**APPENDIX L**  
**IABZSAP Modification 2 - Response to Comments**

CDPHE Comments, dated January 13, 2004	Response
1	<p><u>Section 1.0 (page 1)</u></p> <p>The words "surface and subsurface" have been deleted throughout this document, which is appropriate wherever they are connected to action levels. However, there are distinctions between surface and subsurface sampling methods and how the sampling results are applied to surface and subsurface soil. The words should be inserted back into the first sentence of the first paragraph.</p> <p>Add the words "accelerated action" to the first sentence of the second paragraph ("...streamline the <u>accelerated action</u> decision process...") to distinguish this sampling process from the CRA sampling.</p>	<p>In accordance with the RFCA Modification (June 2003), there are no longer separate ALs for surface and subsurface soil (even though there may be different cleanup levels). Subsurface sampling methods are specifically called out in Section 4.9.3 (page 96).</p> <p>"Accelerated action" will not be added before the words decision process in the first sentence of the second paragraph. As specified in Section 3.1.1, first paragraph, first sen

Figure 1  
Industrial Area Groups

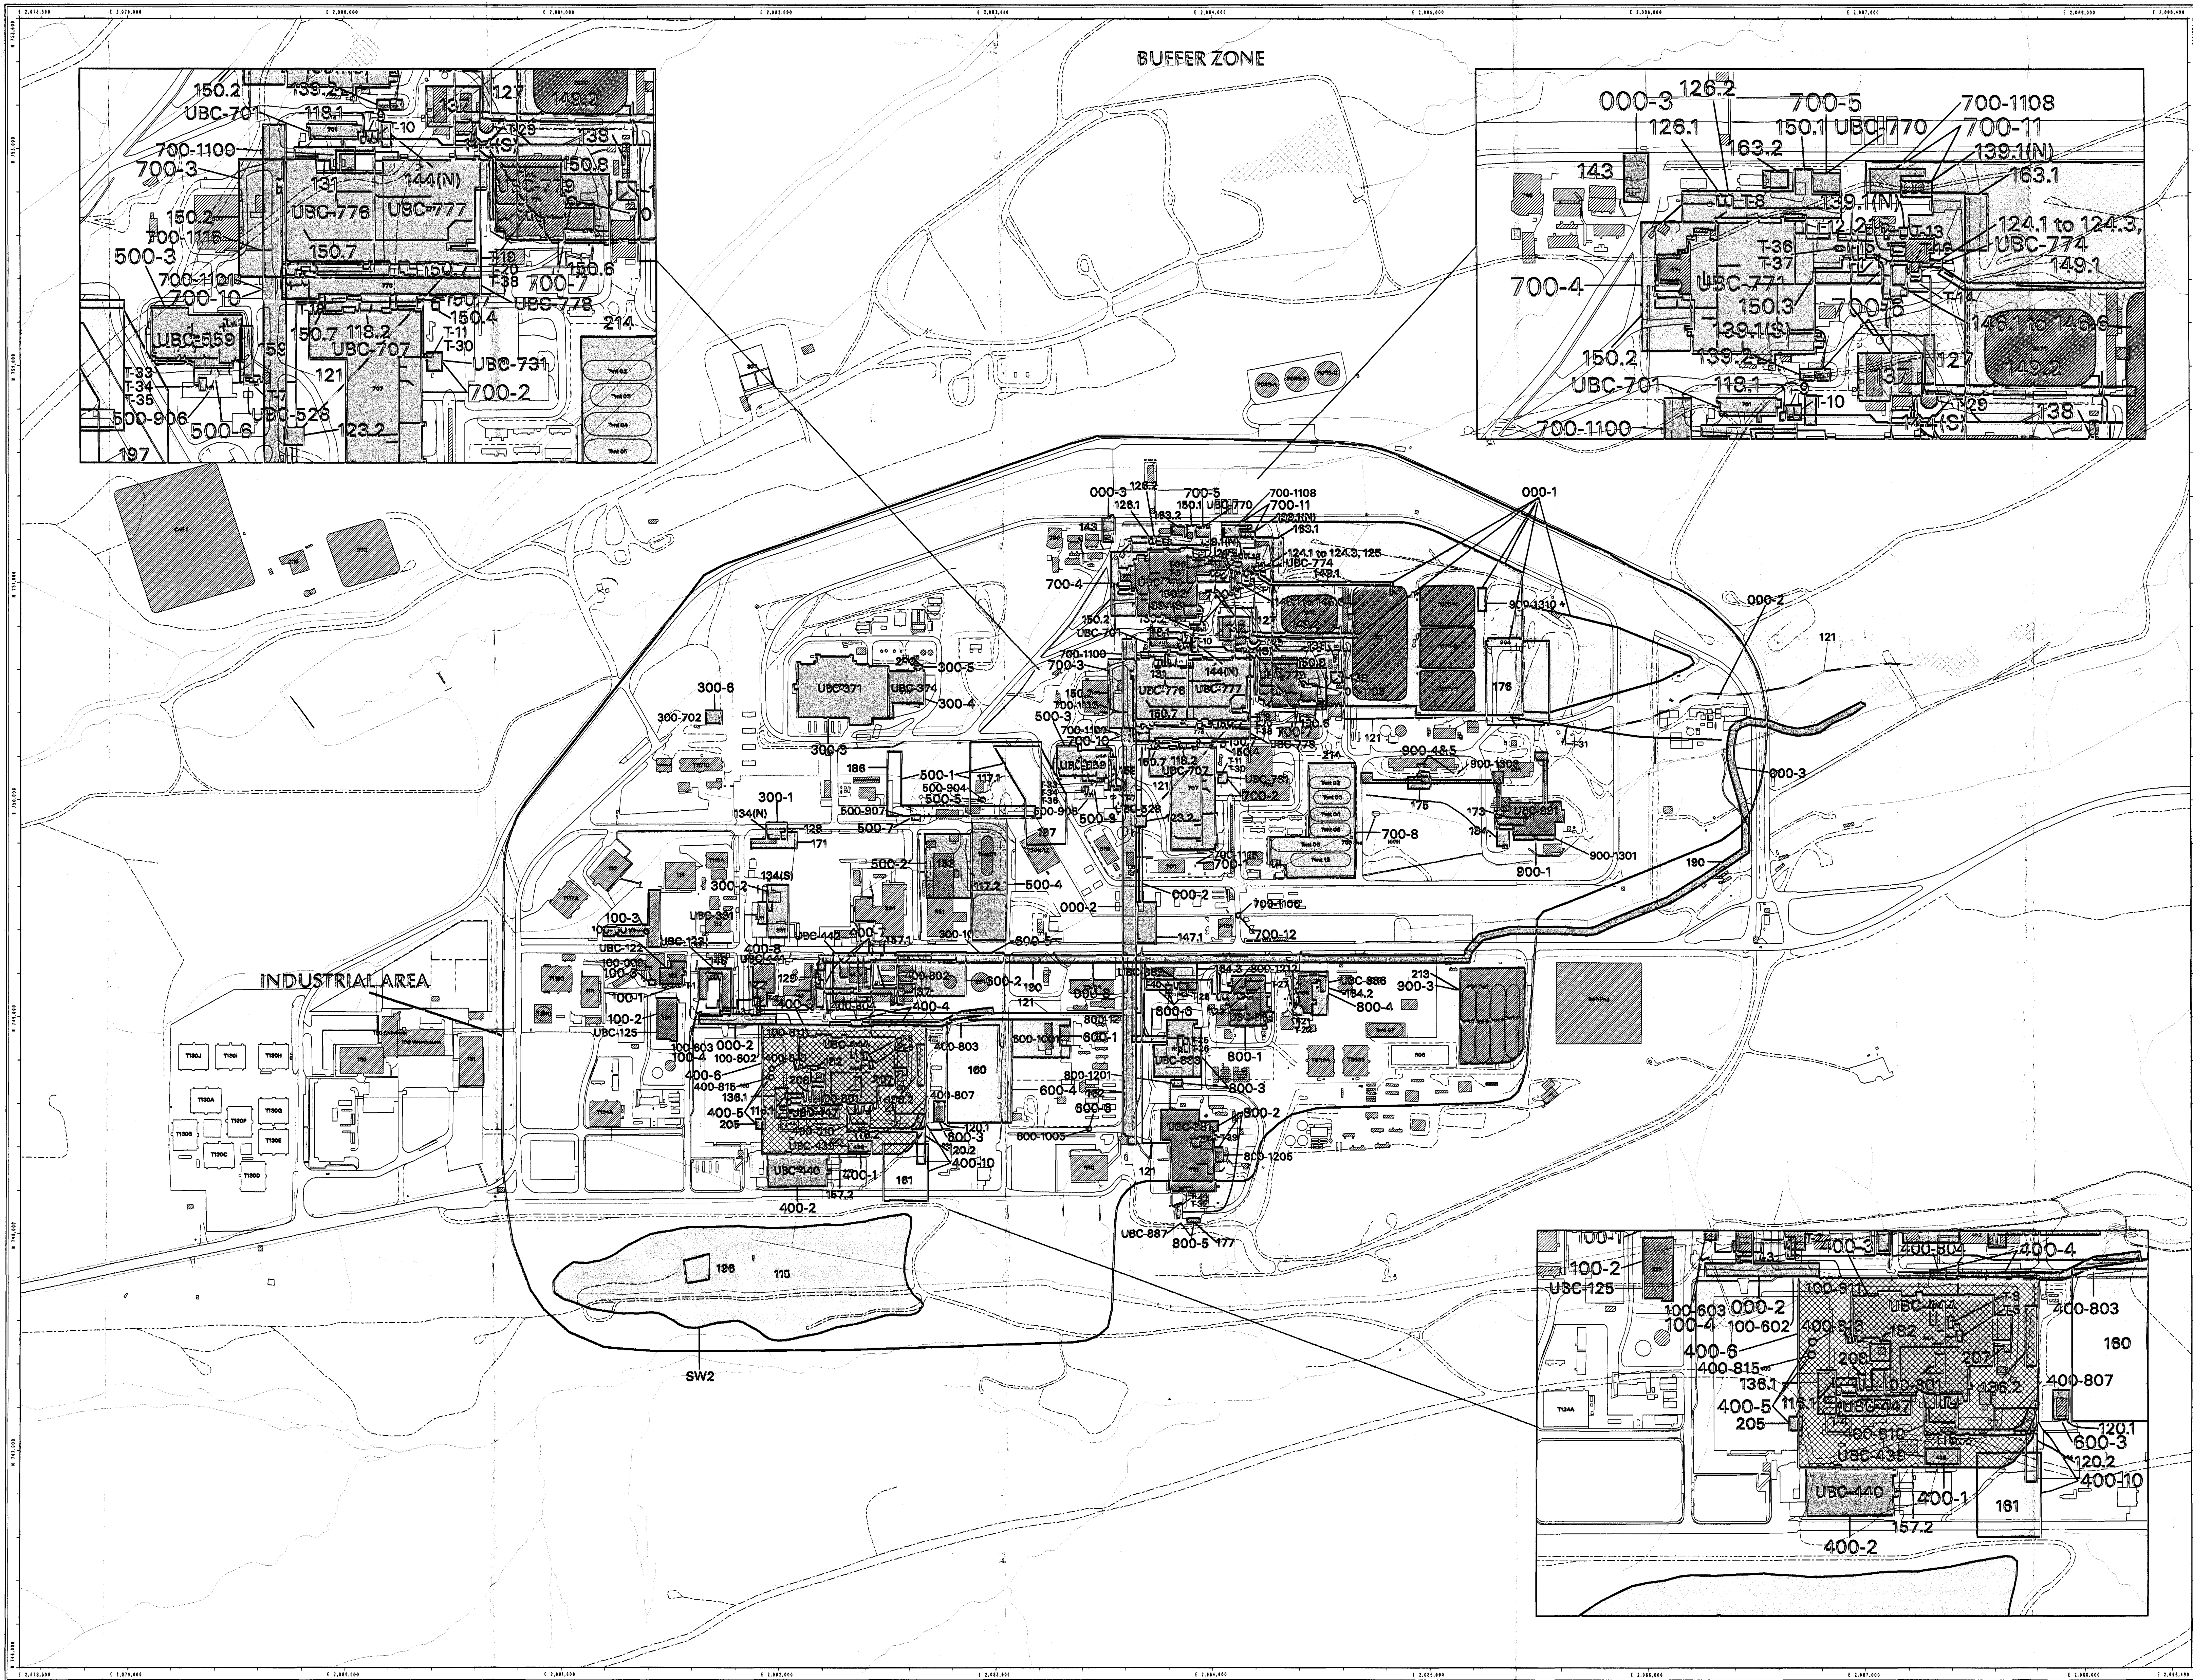
20	<p><u>Section 4.0 (page 66)</u></p> <p>Figure 25 does not show IHSSs, PACs, and UBCs as implied in the first bullet.</p>	<p>The text in Section 4.0, paragraph 1, bullet 1 was changed to "Figures 1 and 2." (page 58)</p>
21	<p><u>Figures 26, 27, and 28</u></p> <p>In these flow diagrams, PCOCs are eliminated and hot spots are evaluated before sampling begins.</p>	<p>These diagrams (now Figures 25, 26, and 27) are used to describe the process, using existing data, to determine sampling locations. Please refer to Figure 35 for information on when hot spots are evaluated.</p> <p>The words "hot spot" on these diagrams was changed to "localized areas of elevated PCOC concentration." Additionally, the text of the lead-in box (Figure 20) was clarified.</p>
22	<p><u>Section 4.2.2 (page 73)</u></p> <p>The paragraph which begins, "This methodology will provide..." could be added to the end of the second method of developing statistical grids. The next paragraph, which begins "At UBCs and IHSSs or</p>	<p>The paragraph break in Section 4.2.2 between bullet 2 and the next paragraph was removed. The second paragraph break in Section 4.2.2 was removed and the text is now part of Method 2. (page 65).</p>
